RE: **Gilbert Subdivision**
Canyon County Parcel R37431017A0

Highway District No. 4 (HD4) has reviewed the preliminary plat application for Gilbert Subdivision of approximately 14.01 acres, located in SE ¼ of the NW ¼ of Section 21 T5N R2W. Applicant is requesting to subdivide the parcel creating 6 residential lots and 1 private road common lot. HD4 provides the following comments on the proposed development:

PRELIMINARY PLAT FOR
GILBERT SUBDIVISION
SITUATE IN THE SOUTHEAST 1/4 OF THE NORTHWEST 1/4 OF SECTION 21,
TOWNSHIP 5 NORTH, RANGE 2 WEST, OF THE BOISE PRINCIPAL MERIDIAN
CANYON COUNTY, IDAHO
JUNE 2025

GILBERT SUBDIVISION
PARCEL: R37431017A0
CANYON COUNTY, ID

PRELIMINARY ROAD
GRADING PLAN

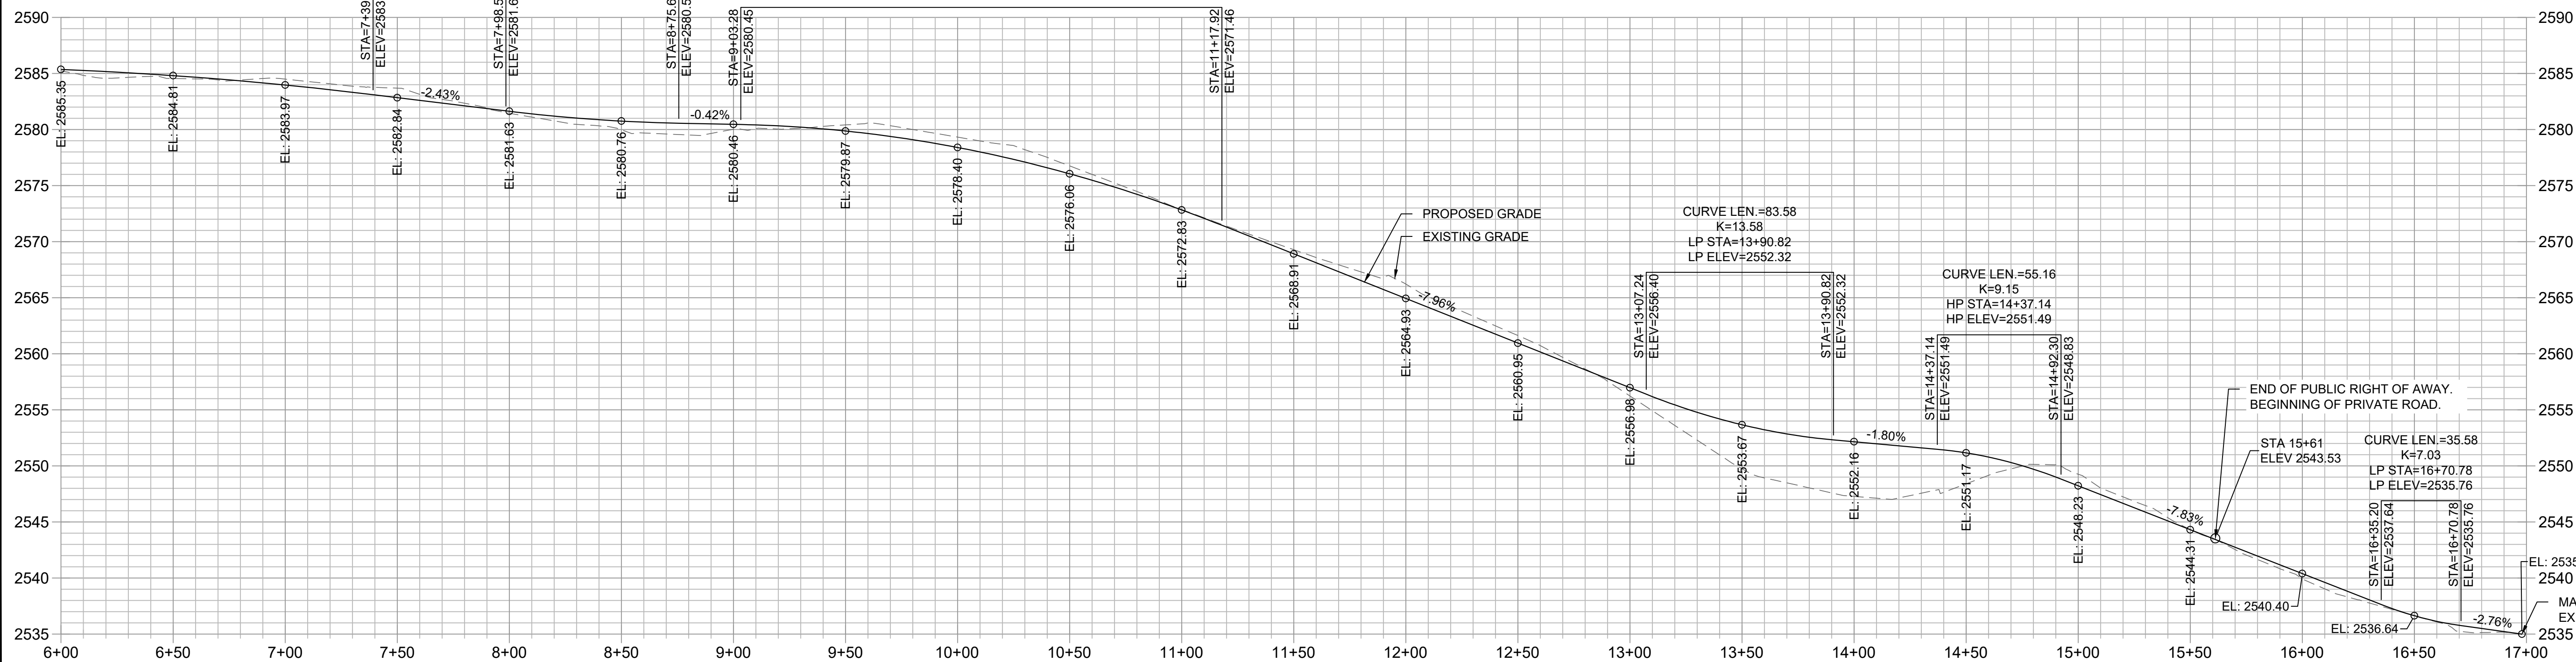
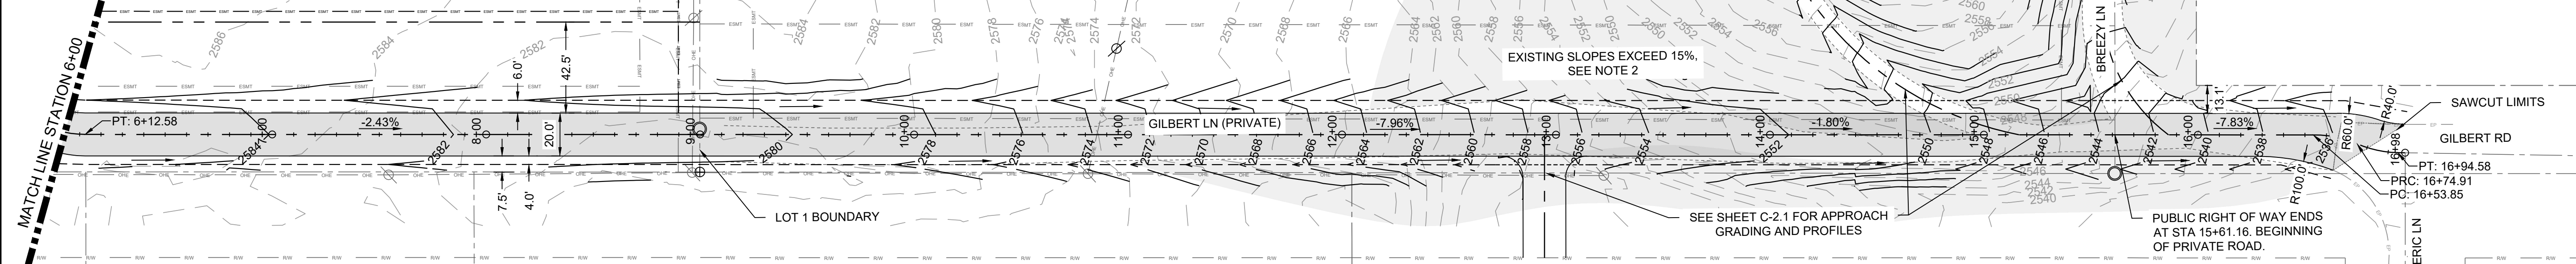
1. Show saw cut limits
2. Roadway design to meet AASHTO
 - a. Review alignments match between Gilbert and road west of Eric

1. Show ROW
2. After road improvements terminate at sta 16+69. What is the profile grade of existing roads? If difference is greater than 1% attempt to add a vertical curve with rate of curvature meeting 25 mph
 - a. Show existing road profile and topo east of terminus
3. With new private road grading and asphalt how does this affect Breezy Lane? Show and grade Breezy Lane into new road improvements. Show existing and proposed profile grade

PRELIMINARY GRADING &
DRAINAGE PLAN

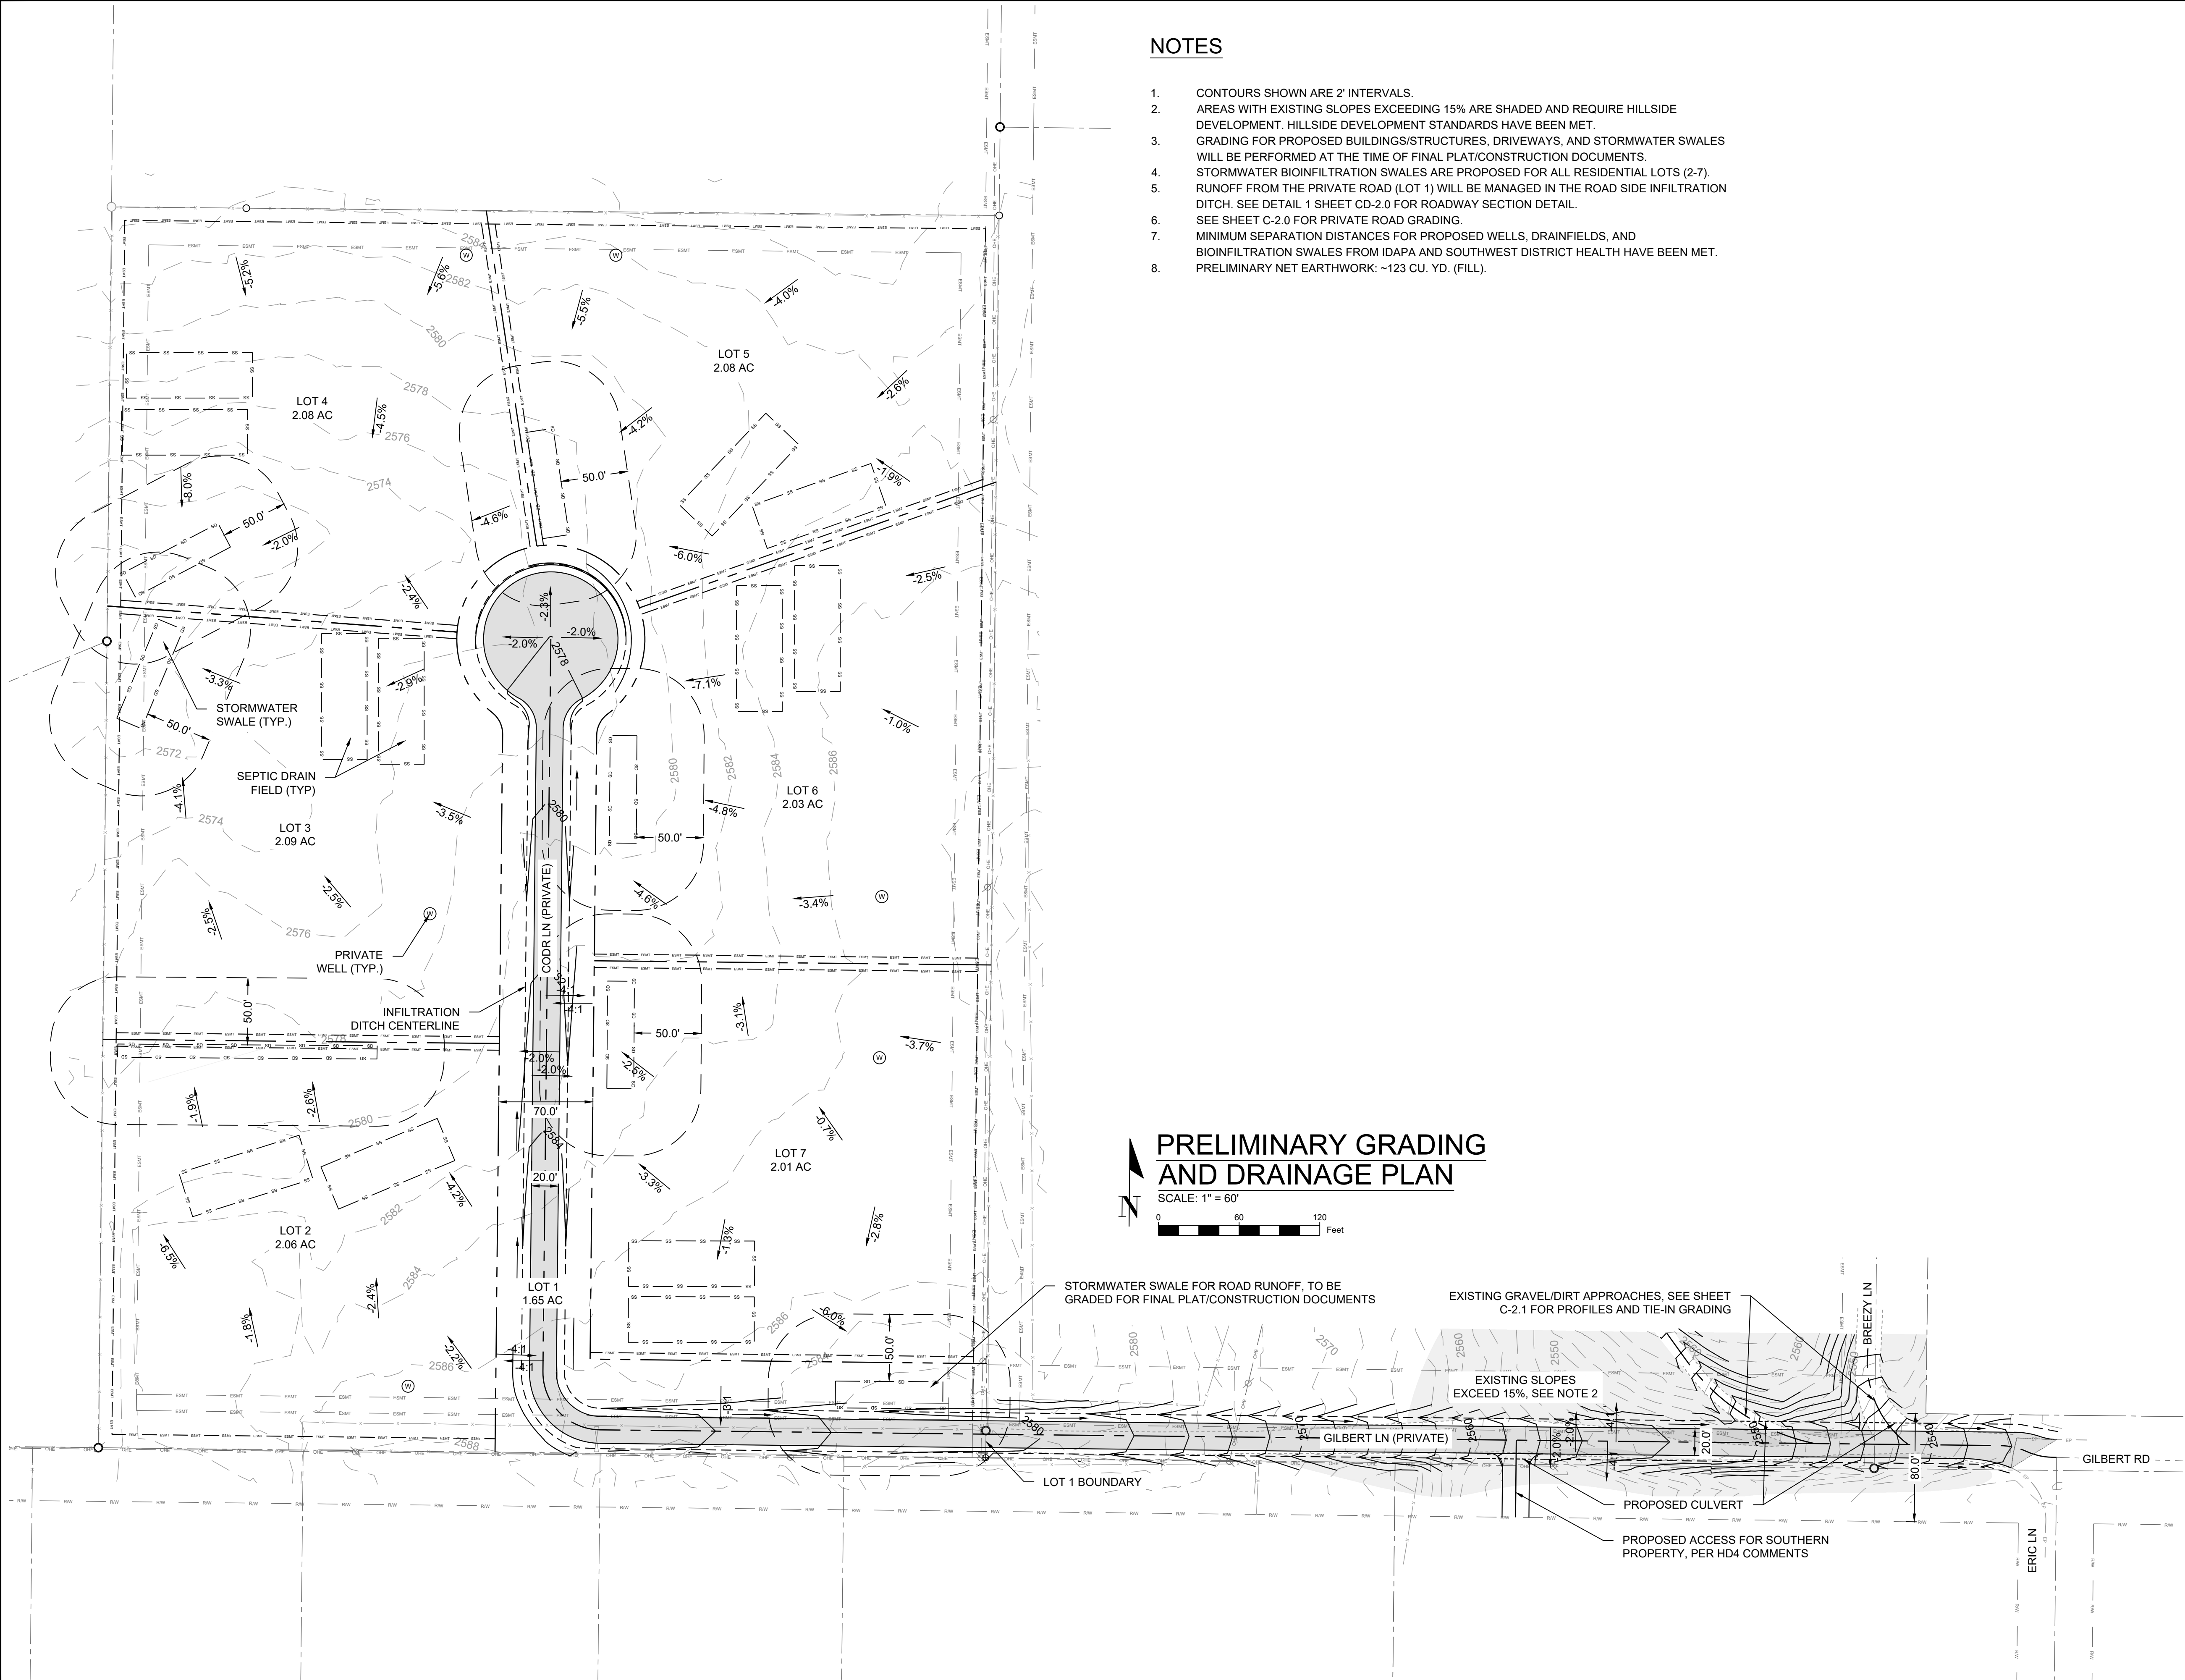
3. All drainage to be retained onsite. Plan drainage at Sta 9+00 adjacent to road or by other appropriate means. Use HD4 calc method. Intent is to prevent road drainage and lot drainage from continuing east on private road.

4. Existing drain pipe 90' east of Eric/Gilbert attempt to put balance of drainage here.
 - a. Appears drainage that will continue into this pipe is from sta 14+75 to end

1. Add an area outside the public right-of-way within an easement for storm drainage.
 - a. See sta 9+00 comments above
2. Add note, "The Homeowners Association, underlying property owner or adjacent property owner is responsible for all storm drainage facilities outside the public right-of-way, including all routine and heavy maintenance."

STORMWATER SWALE FOR ROAD RUNOFF, TO BE
GRADED FOR FINAL PLAT/CONSTRUCTION DOCUMENTS

PROPOSED ACCESS FOR SOUTHERN
PROPERTY, PER HD4 COMMENTS
